CONTRACT CHANGE ORDER NO. 36
SHEET 2 OF 7

TOWER ANCHORAGE DETAILS NO. 2

SAN FRANCISCO OAKLAND BAY BRIDGE
EAST SPAN SEISMIC SAFETY PROJECT

SELF-ANCHORED SUSPENSION BRIDGE
(SUPERSTRUCTURE & TOWER)

DETAIL A
TOWER BASE PLATE LAYOUT
1:20
(Tower base stiffeners are not shown for clarity)

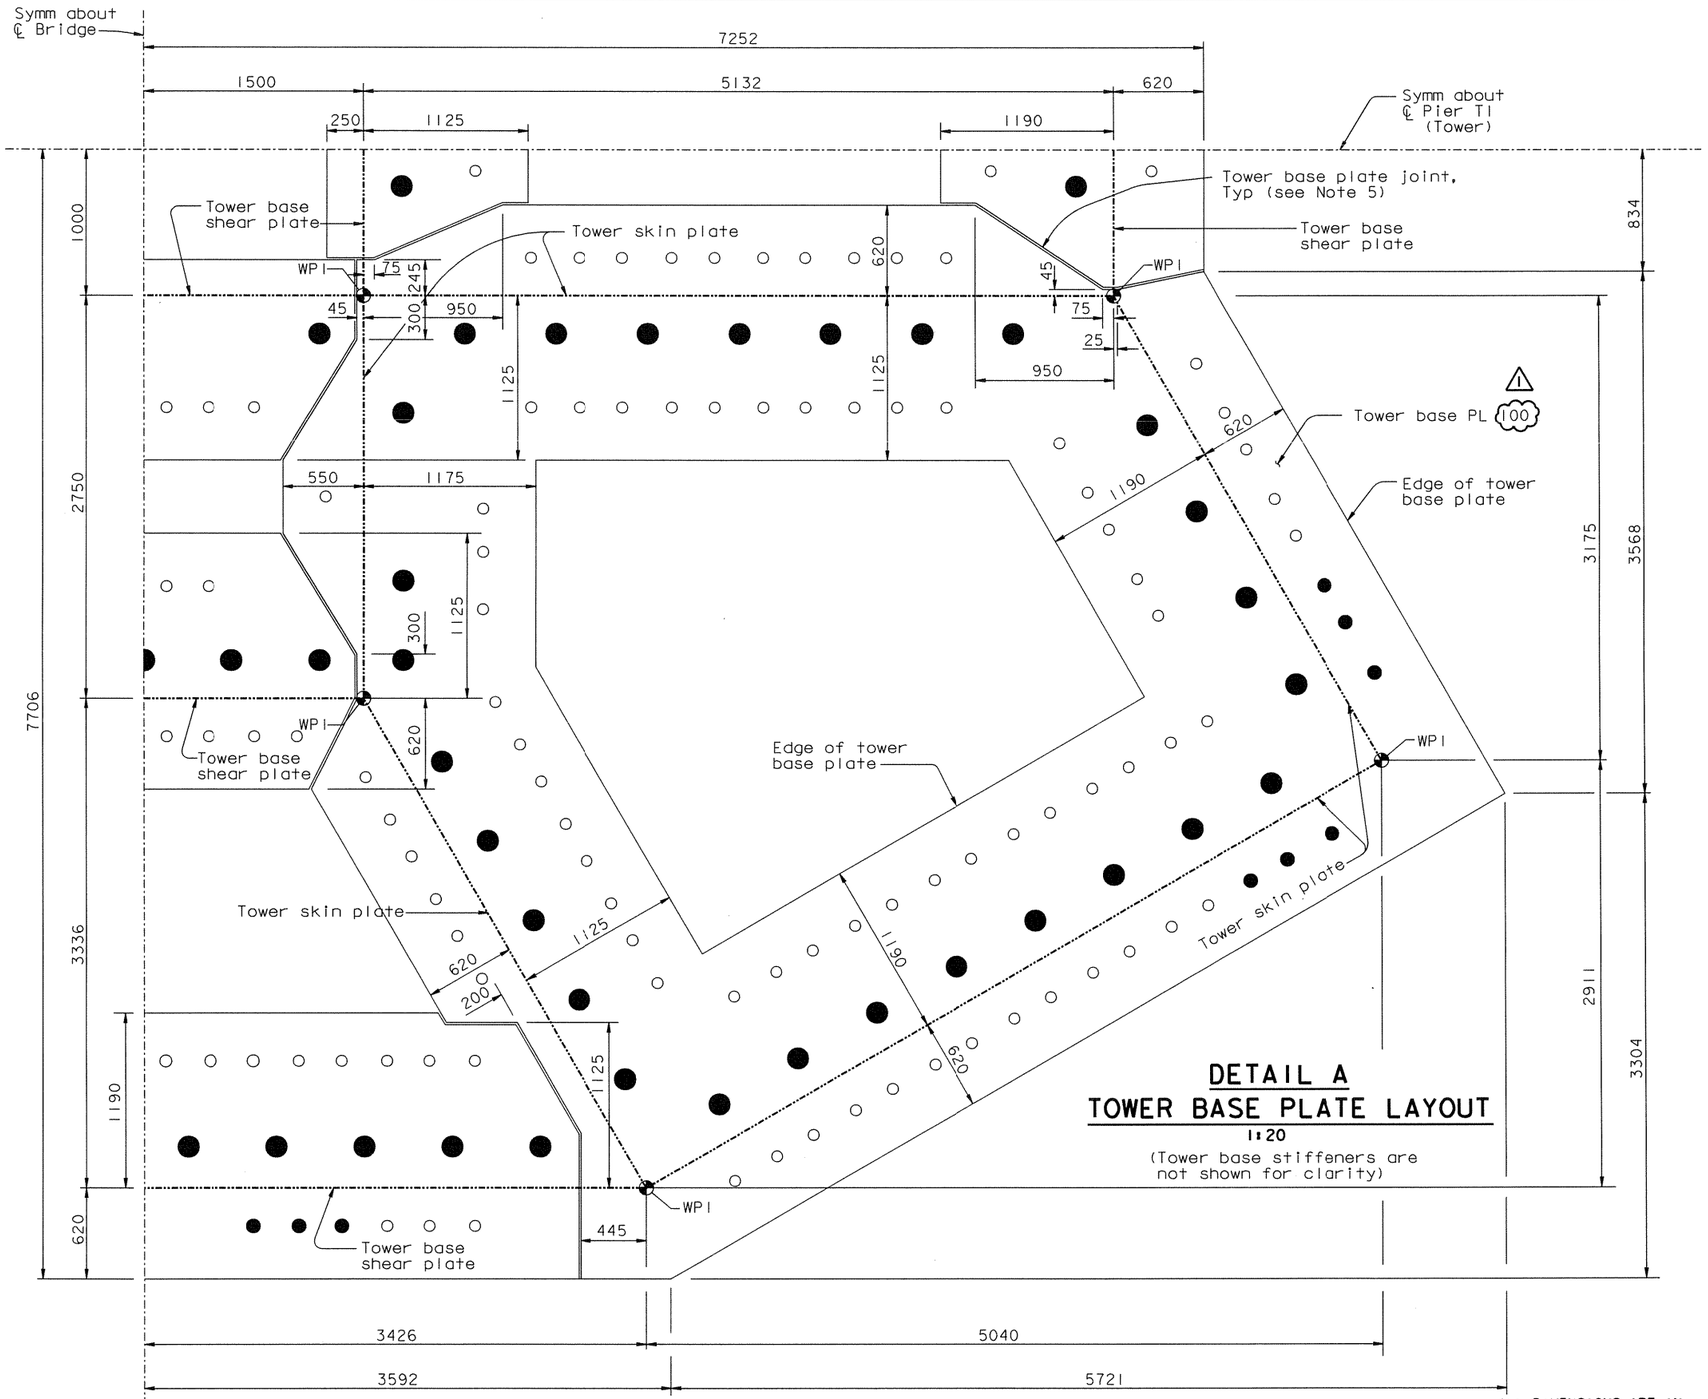
MARK	DATE	DESCRIPTIONS	BY	CH'D	CCO#
1	02/28/07	TOWER BASE PLATE	AS	MN	36

DETAIL A
TOWER BASE STIFFENER LAYOUT
1:20

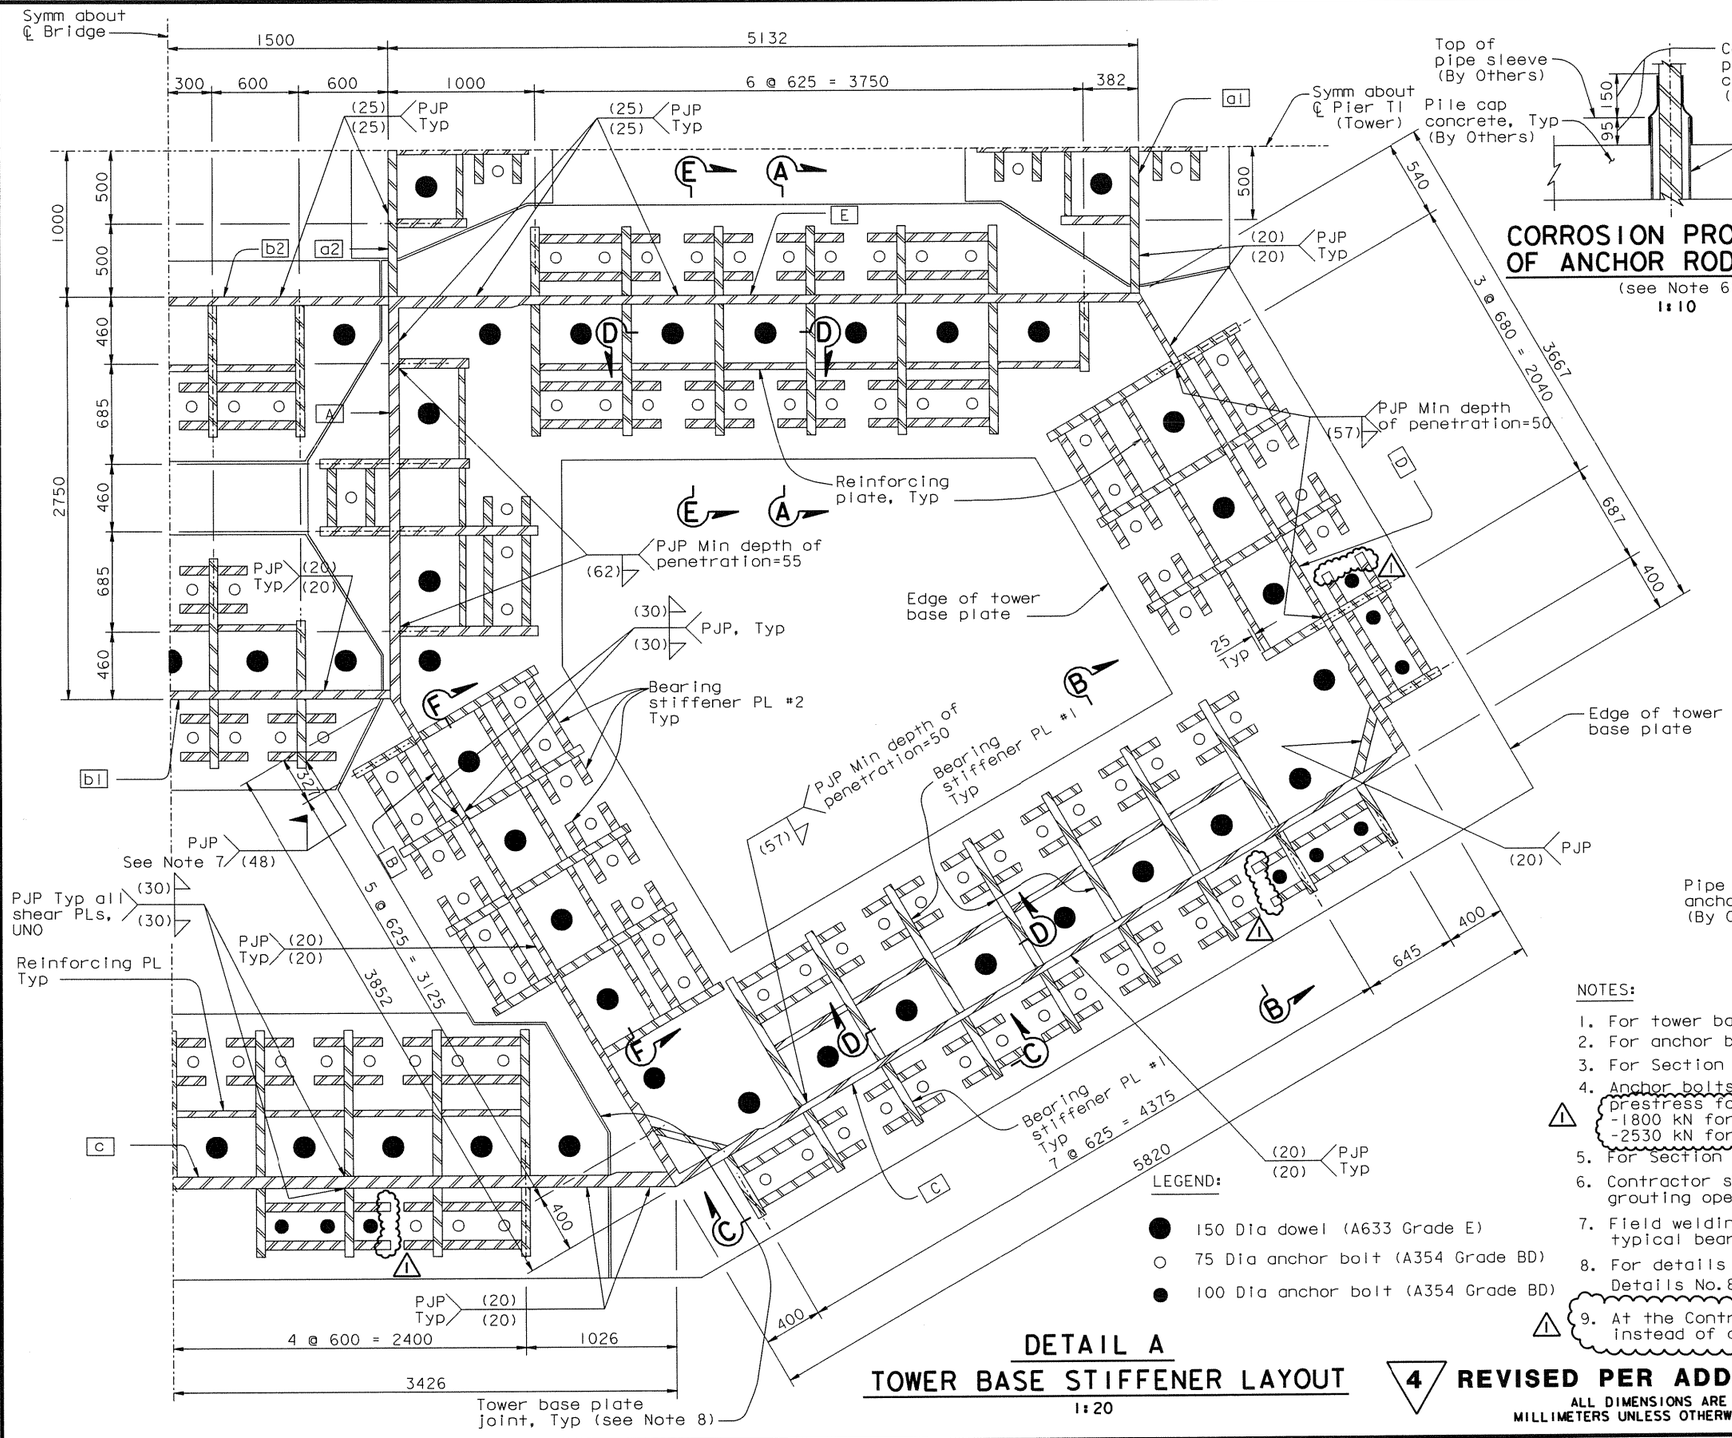
MARK	DATE	DESCRIPTIONS	BY	CH'D	CCO#
1	05/11/07	TOWER STIFFENERS	MN	NV	36

TOWER ANCHORAGE DETAILS NO. 5

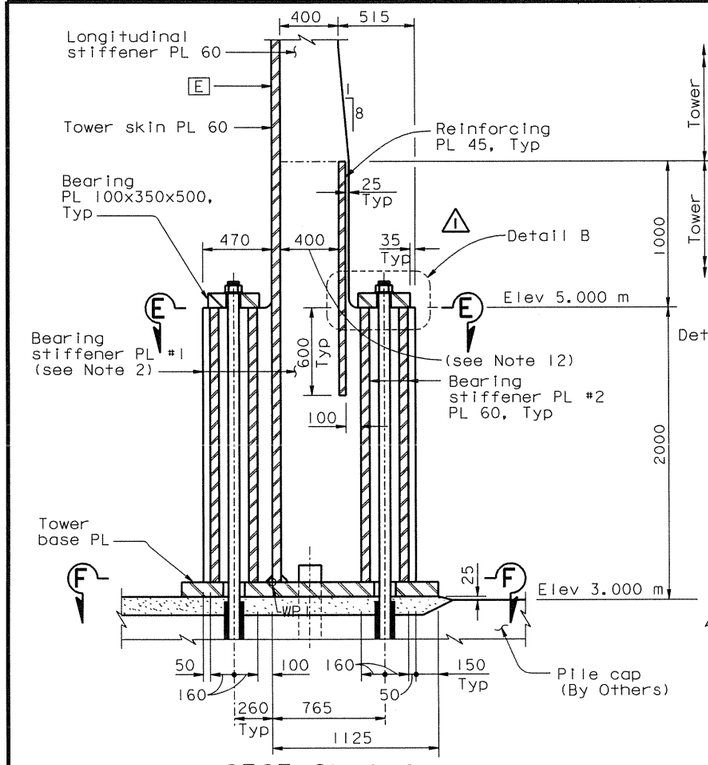
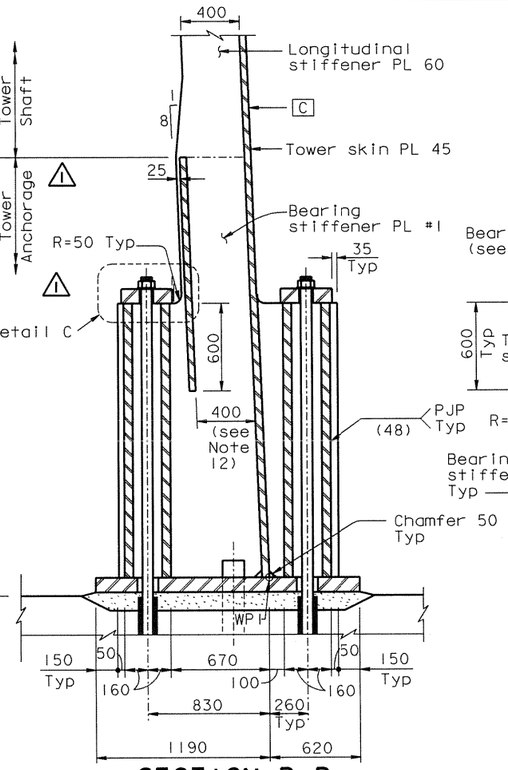
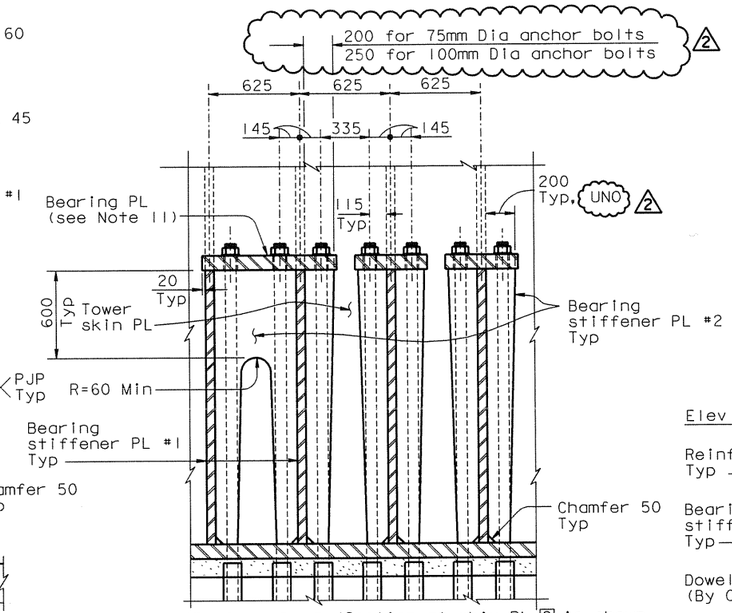
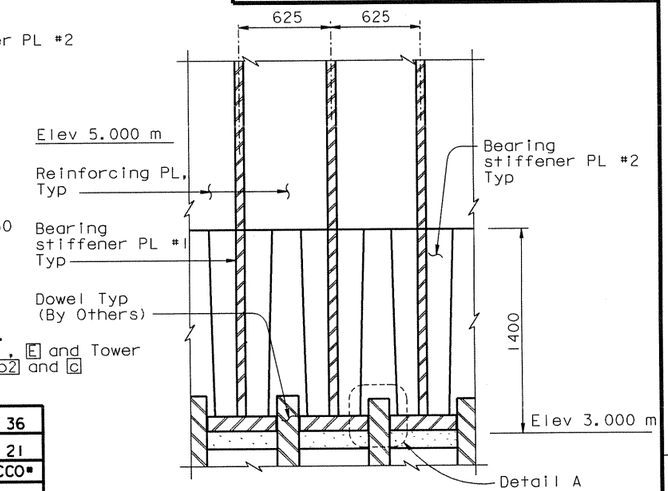
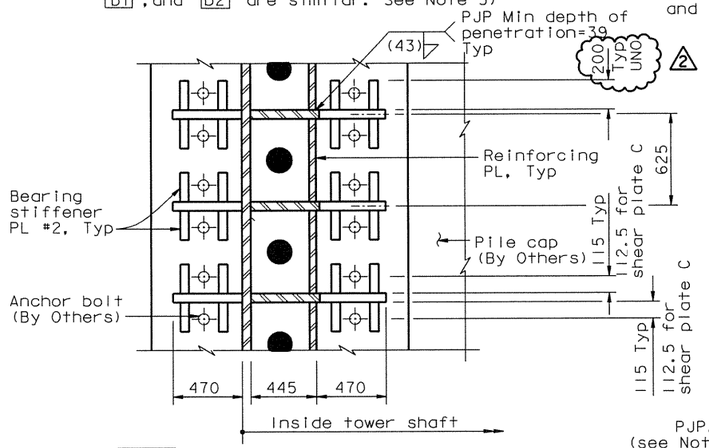
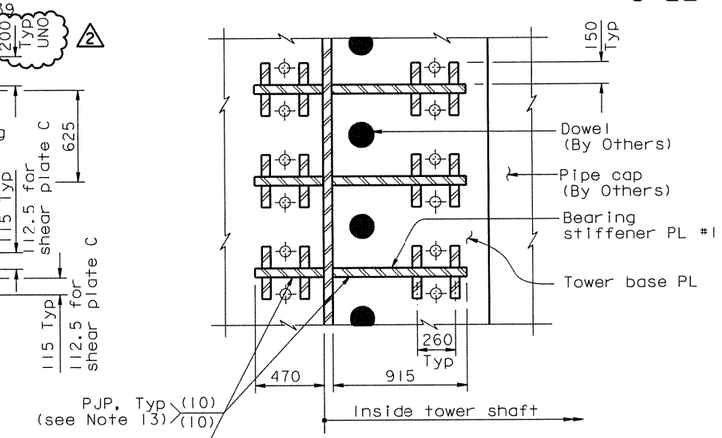
MARK	DATE	DESCRIPTIONS	BY	CH'D	CCO#
2	05/11/07	TOWER STIFFENERS	MN	NV	36
1	06/23/06	DELETE GAP TABLES	MN	NV	21

TOWER ANCHORAGE DETAILS NO. 6

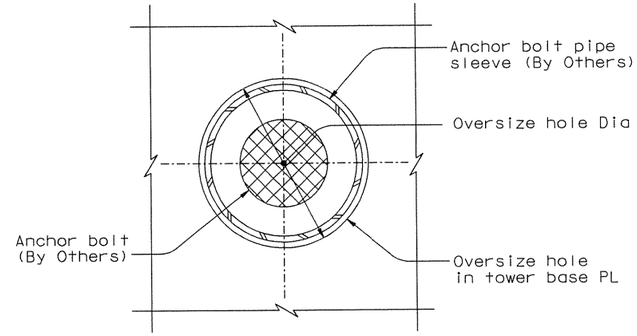
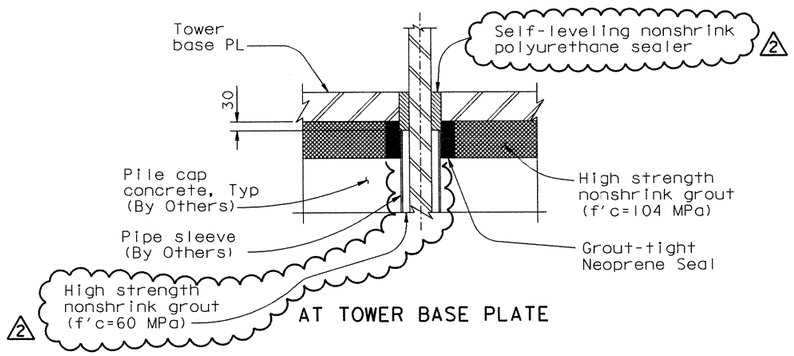
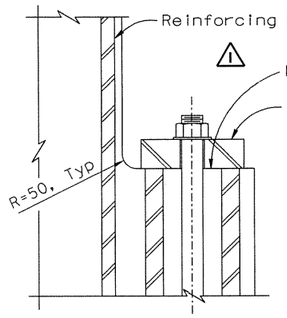
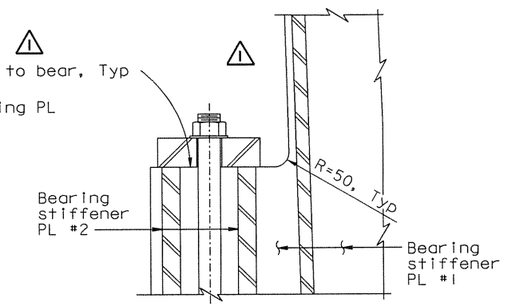
MARK	DATE	DESCRIPTIONS	BY	CH'D	CCO#
2	02/28/07	TOWER BASE PLATE	JD	MN	36
1	06/23/06	DELETE GAP TABLES	MN	NV	21

DOWEL ANCHORAGE CONTINGENCY DETAIL (see Note 2)

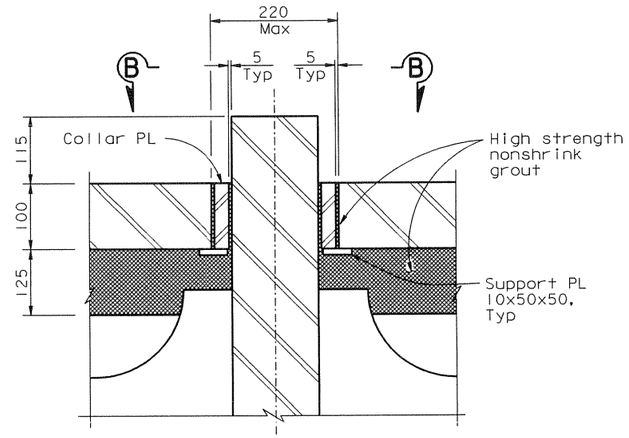
MARK	DATE	DESCRIPTIONS	BY	CH'D	CCO#
2	04/03/07	TOWER BASE PLATE	JD	MN	36
1	02/28/07	TOWER BASE PLATE	JD	MN	36

1. For dowel layout, see "Tower Anchorage Details No.3" sheet.
2. Oversize hole in tower base PL is an acceptable alternative to accomodate tolerance requirements for the erection of the tower base plate. Collar plates shall be A709M Gr.345 and shall be fabricated based on field measurements and then installed.

TOWER ANCHORAGE DETAILS NO. 8

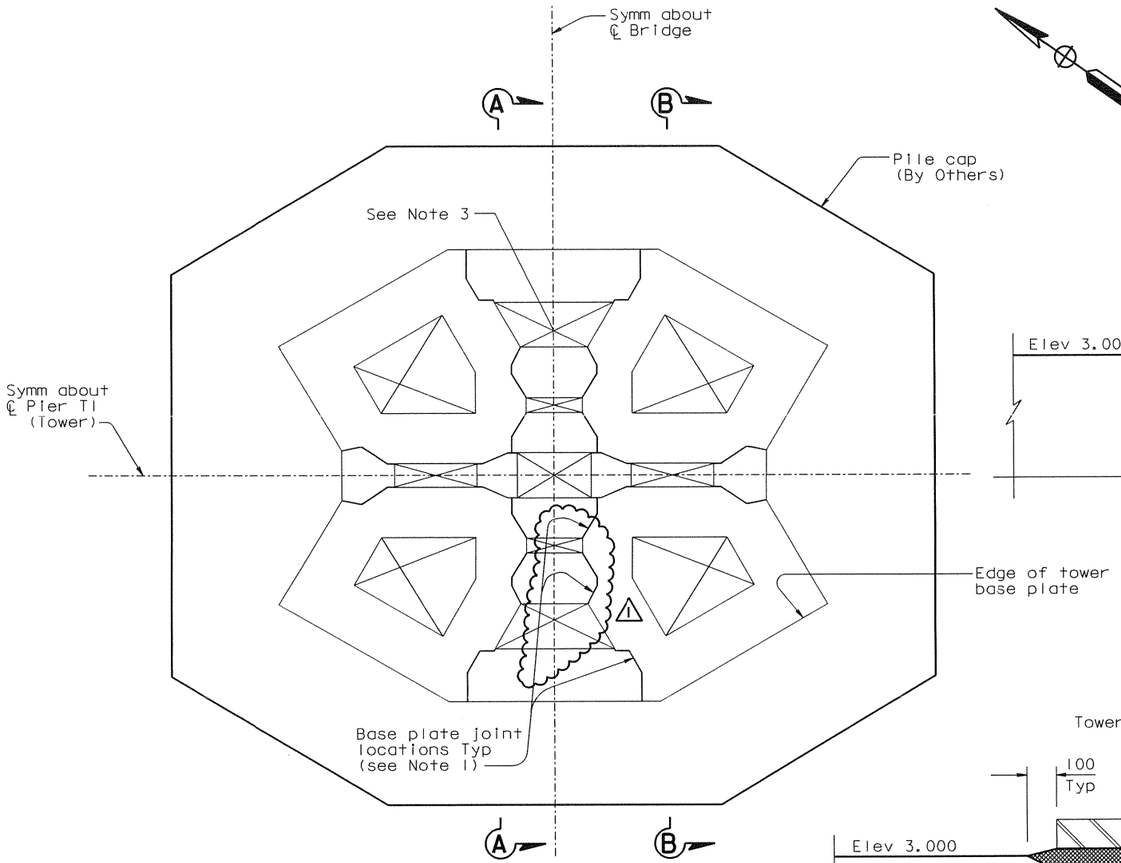
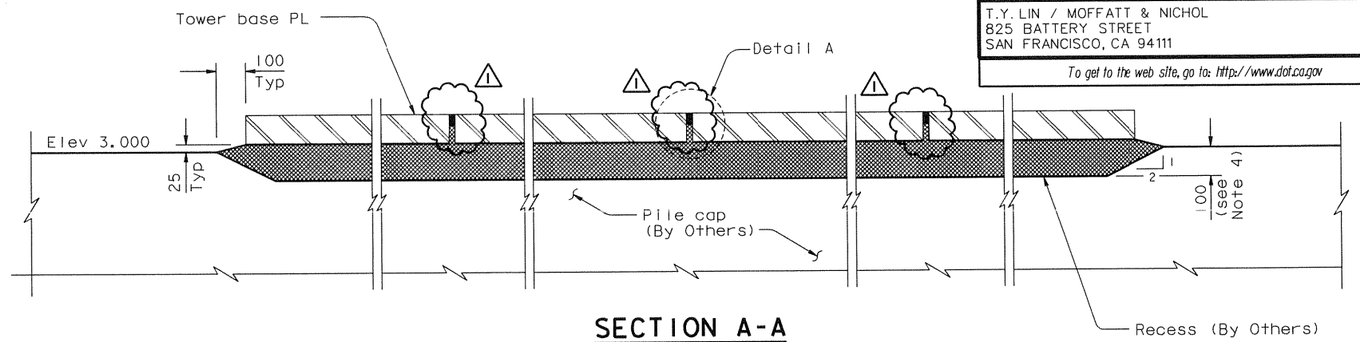
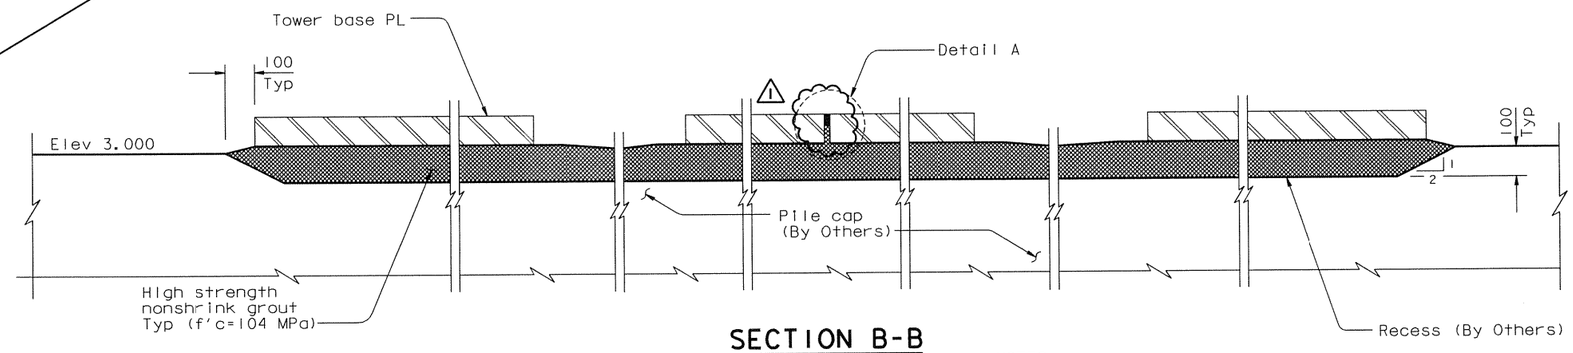
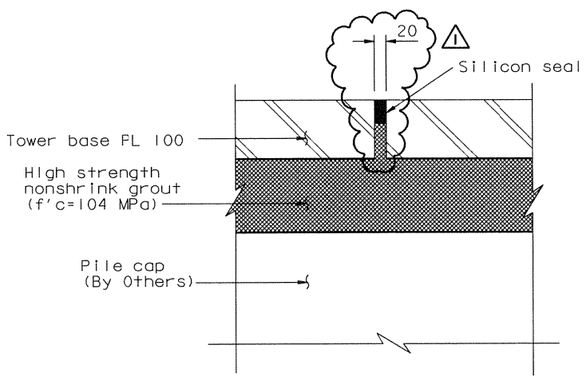
MARK	DATE	DESCRIPTIONS	BY	CH'D	CCO#
1	02/28/07	TOWER BASE PLATE	AS	MN	36
